# Freescale Semiconductor

MPC185CE Rev. 9, 10/2004

# XPC185 Security Processor Device Errata

This document details all known silicon errata for the XPC185 and its derivatives. Table 1 provides a revision history for this document.

Figure 1. Interrupt Mask Register

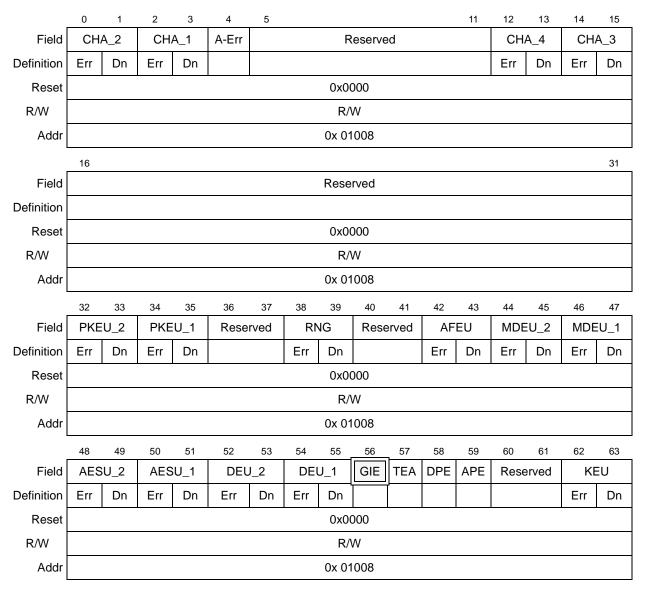
The XPC185's interrupt registers reset to an unmasked state. While not an errata, having interrupts masked following reset simplifies the user's task during system debug and initial bring-up.

A new bit has been added to the MPC185VFB Interrupt Mask Register. This change has been made in Rev.B (XPC185VFB) silicon and all subsequent revisions. MPC185 User's Manual has been updated to reflect this change. The revised Interrupt Mask Register and bit definitions are shown in Figure 1.
